City of Fitchburg
Planning/Zoning Department
5520 Lacy Road
Fitchburg, WI 53711
(608-270-4200)

LAND DIVISION APPLICATION

Permit Request No. CS-2330-20

Application: RZ-2331-20 & CS-2330-20
Property Location: Lot 4 CSM 10315
Review Date: January 7, 2020
Planning Staff Review #1

CERTIFIED SURVEY MAP

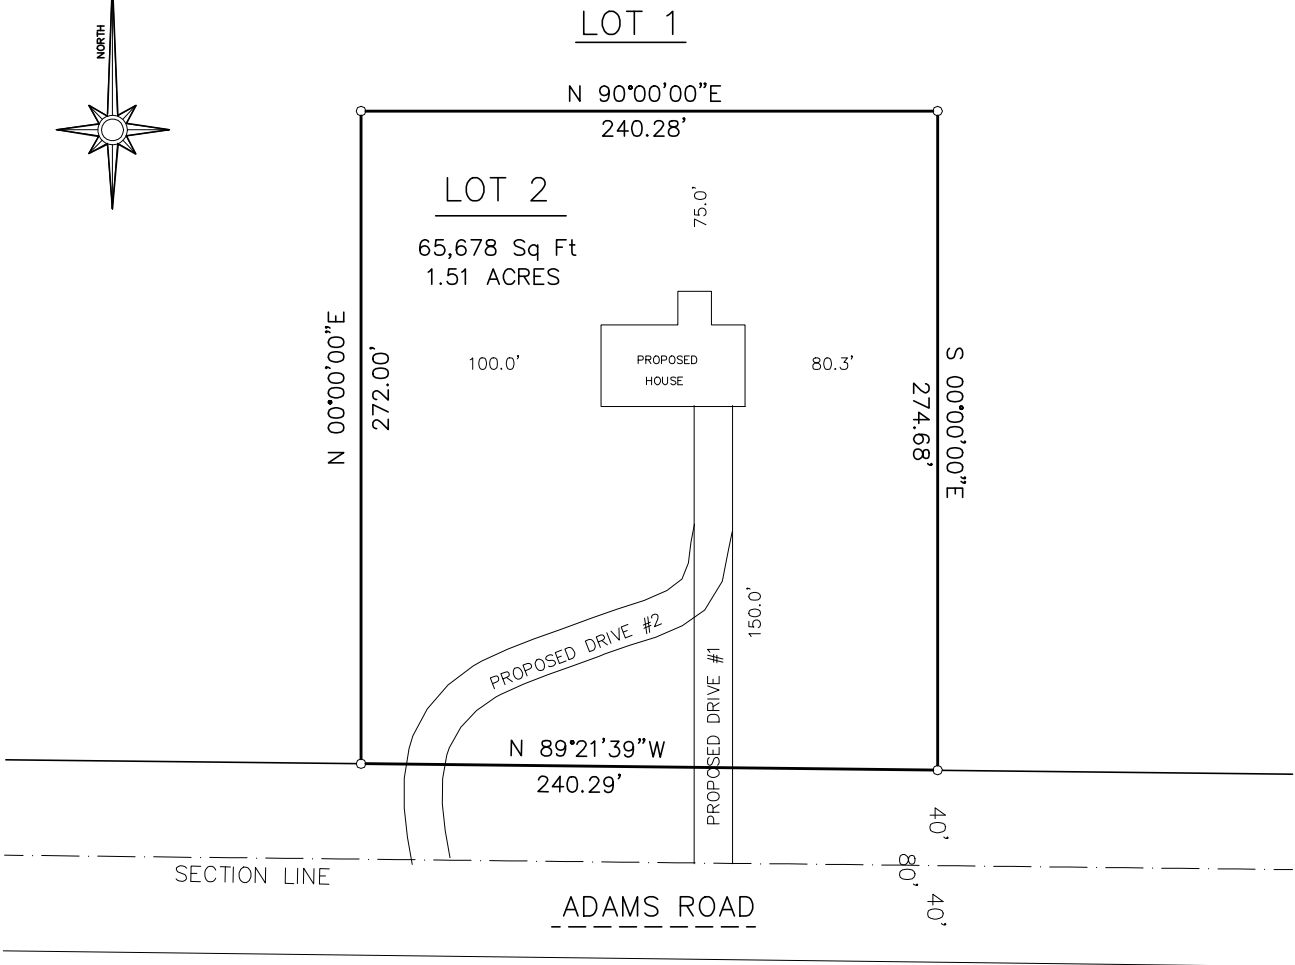
1. Driveway permit will be required for new driveway.
2. Verify location of driveway (CSM appears on west side of lot, site plan shows east side).
